# Chemung Watershed, NY Area of Interest

## INDEPENDENT QUALITY CONTROL REPORT

Task Order HSFEHQ-10-J-0006

**Figure 12: Checkpoint CH\_A\_12 removed from the vertical accuracy assessment**

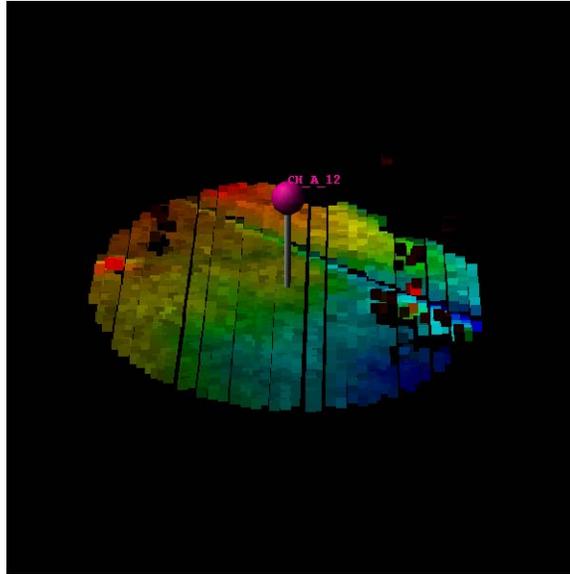
Four points were removed before conducting the vertical accuracy assessment. Because the vertical accuracy assessment was performed on the first return points in the full point cloud, there are vegetation points that do not represent the true ground

surface that can introduce error into the vertical accuracy test (see Figure 12, 13, and 15). There are also points along the edge of the flightline that would not be used in the ground classification that can introduce error into the vertical accuracy test (see Figure 14). The following figures illustrate the points that were eliminated from the vertical accuracy assessment.
